**Los Altos Hills Open Space Committee
Regular Meeting Minutes
9:00 AM, January 8, 2020
Los Altos Hills Town Hall, Heritage House**

Attachment A	OSC Review 24269 Dawnridge Drive
Attachment B	OSC Review 13940 La Paloma Road
Attachment C	OSC Review 14210 Baleri Ranch Road
Attachment D	Proposed Amendment to the Fence Ordinance
Attachment E	Presentation from Jonathan Buck, Engeo

From: Open Space Committee
Date: 8th January 2020
Property address: 24269 Dawnridge Drive
Date of Site Visit: 6th January 2020

Lands of	Lim	APN	33618019
Town Planner	Jeremy Loh	Project Number	SD19-0089

Plans (Hale Creek on neighboring property to the RHS)

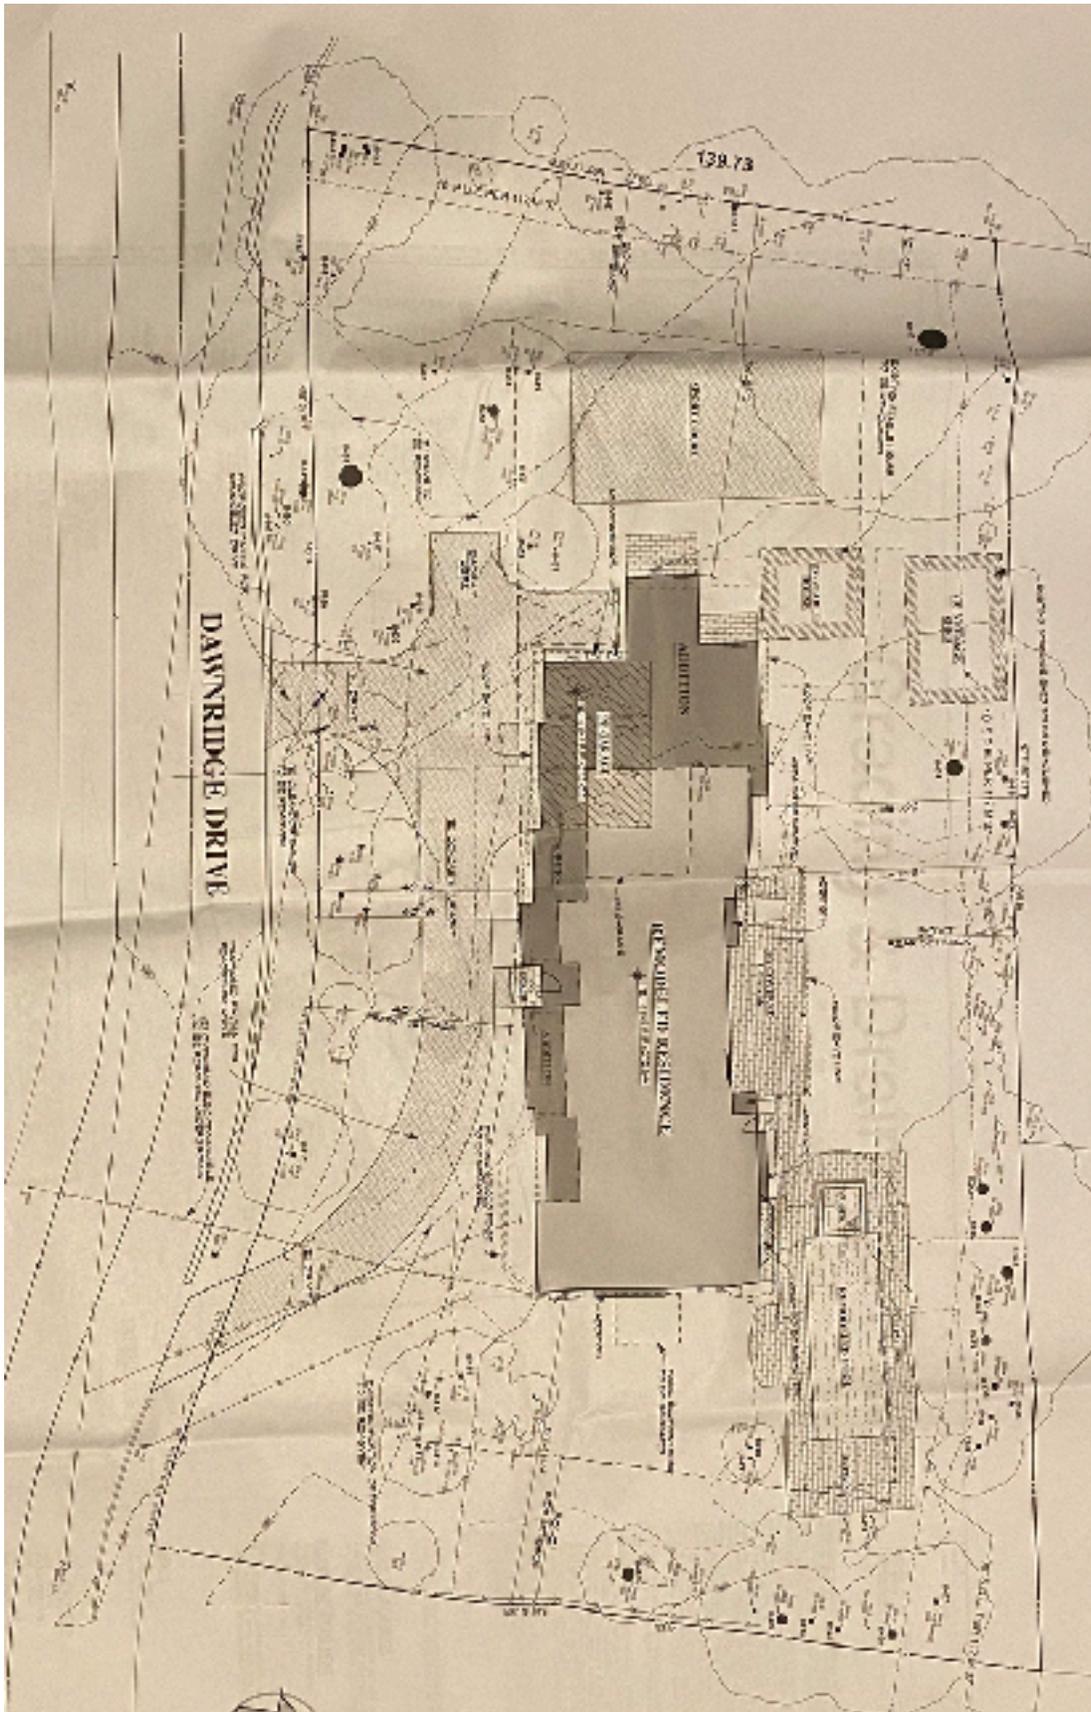
From an Open Space perspective the only issue appears to be the close proximity, albeit on neighboring property, of Hale Creek.

Currently there is a retaining wall with a fence on top within 25 feet of top of bank (disallowed under LAH Resolution 26-07)

Remove fence and ivy from creekside. Any replacement fence needs to be 25' from top of bank. Consider removing stacked wood from base of Valley Oak. Consider removing rodenticide.

- A. Remove fence and invasive ivy from creek side. Any replacement fence should be placed 25 feet from top of bank.
- B. Remove wood stack from the base of the Valley oak tree.
- C. Remove rodenticide from riparian habitat zone.
- D. Require the developer to dedicate an open space easement, and enforce a riparian setback, 25 feet of top of bank of Hale creek.
- E. Request the developer to evaluate the removal of the retaining wall at the creek. This would allow a more natural creek environment.

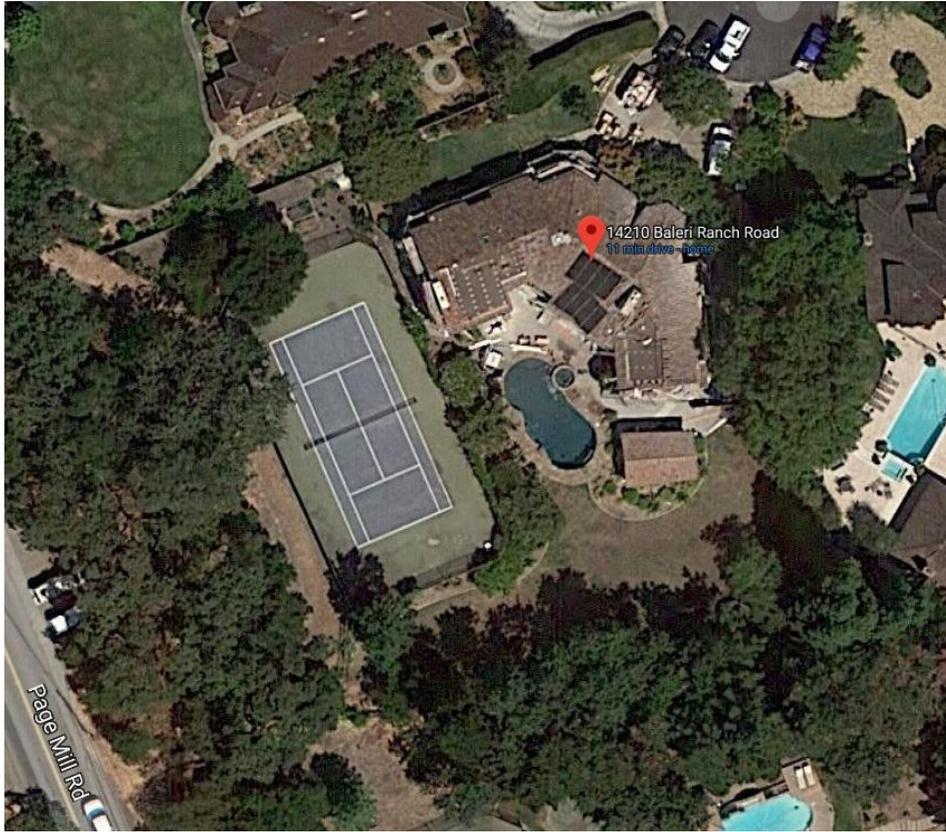
- Project scope: Outdoor kitchen, pergola, paving, fire pit, soaking tub, planting, new fencing.
- The site includes a portion of Matadero Creek.
- There is a 10' wide pedestrian and equestrian easement along southern edge of the property. This pathway is shown on the official Town's Pathways Map and the original Baleri Ranch Road preliminary development plan (see below).
- The preliminary development plan also indicates a possible SCVWD easement along creek on the western edge of the property.
- It's not clear if the plan calls for the removal of an existing plastic/wire fence located within the pedestrian/equestrian easement.
- The plan indicates a 10' public utility easement and an adjacent 10' drainage easement along the south edge of the property.
- The plan does not show the pedestrian/equestrian or SCVWD easements.
- The plan does not show the location of Matadero Creek.

- Notify the Pathways Committee that this project could impact the existing pedestrian/equestrian easement.
- Request the developer dedicate an Open Space Easement on the entire width of the pedestrian/equestrian easement along the south side of the property to insure access for wildlife to Matadero Creek.
- Request the developer dedicate an Open Space Easement along Matadero Creek extending 25' from top-of-bank.
- Verify that fencing does not impede the pathway easement or proposed open space easements.
- Verify that there is a SCVWD easement as indicated on the Baleri Ranch preliminary development plan.
